## Safety Recall Action Notice 584 Issue 1 - 08.2020

Subject: VIN Label Protector Fitment			
Bulletin Number	Models Affected	VIN Range	Markets Affected
584	Street Scrambler	From VIN 914448 to VIN AC6893	All Markets Except China
584	Street Twin	From VIN 914973 to VIN AC6893	All Markets Except China

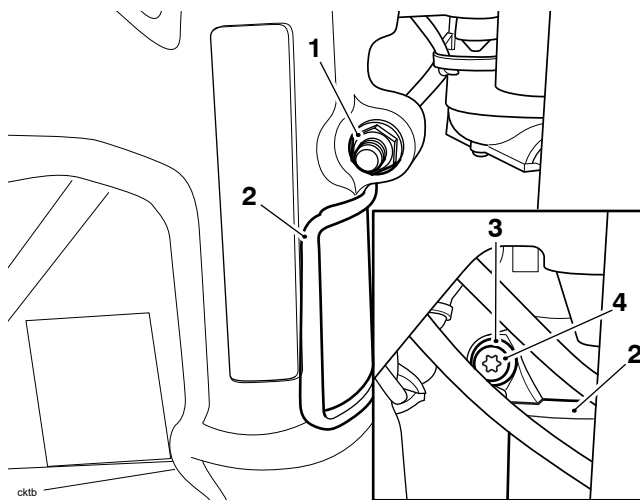
The instrument branch of the harness should be checked for orientation and, if necessary, modified to the correct orientation as described in the harness rework procedure below.

3. Align the new VIN label protector to the frame as shown. Fit the flanged sleeve, screw and new lock nut to the VIN label protector and tighten the screw to **3 Nm** whilst holding the lock nut.

Side view

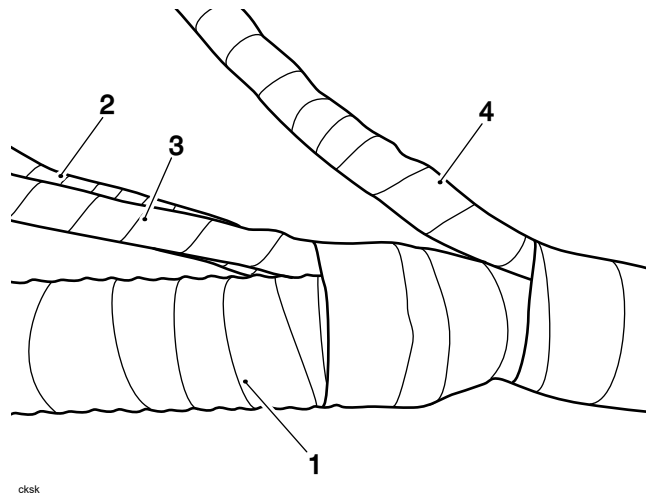
12. Check the orientation of the harness. The switch housing branch should sit behind the ignition branch and the headlight and DRL branches should be situated above. The DRL branch should be inboard of the headlight branch. The instrument branch should be situated above as shown in the illustration below.

Graphic showing incorrect taping of ignition branch conduit

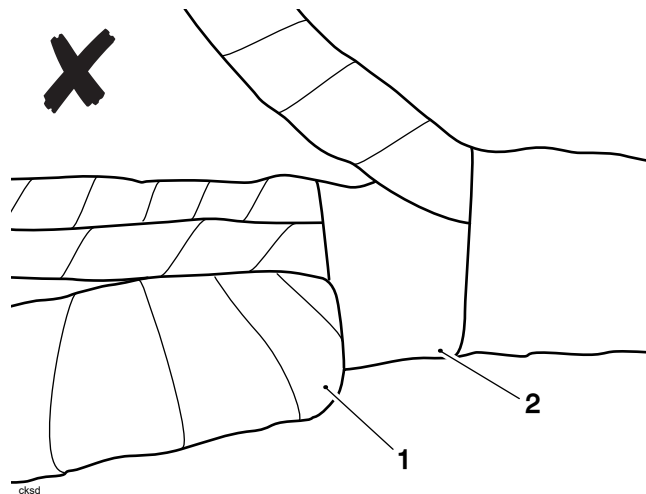
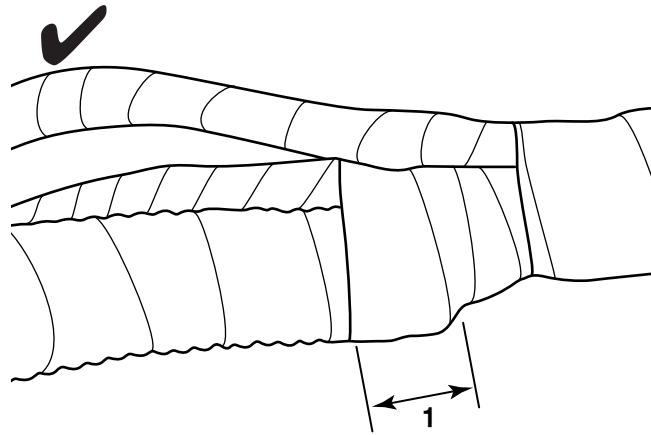
13. Check the ignition branch conduit has been correctly taped. The tape covering the four branches (Ignition branch, Switch Housing branch, Headlight branch and DRL branch) should overlap the ignition branch conduit by 10 - 15 mm.

14. If the ignition branch conduit taping is incorrect, apply tape to all four branches forward of the instruments branch. The tape should be overlapped by at least 10 mm working forward until the ignition branch conduit is overtaped by 10-15 mm as in the illustration above.
15. If the ignition branch conduit taping is correct or has been corrected, continue from the next step.
16. Lift the headlight and DRL branches upwards and apply tape across the ignition and switch housing branches. The tape should wrap round at least twice, be one tape width wide, with the tape squarely aligned with itself.
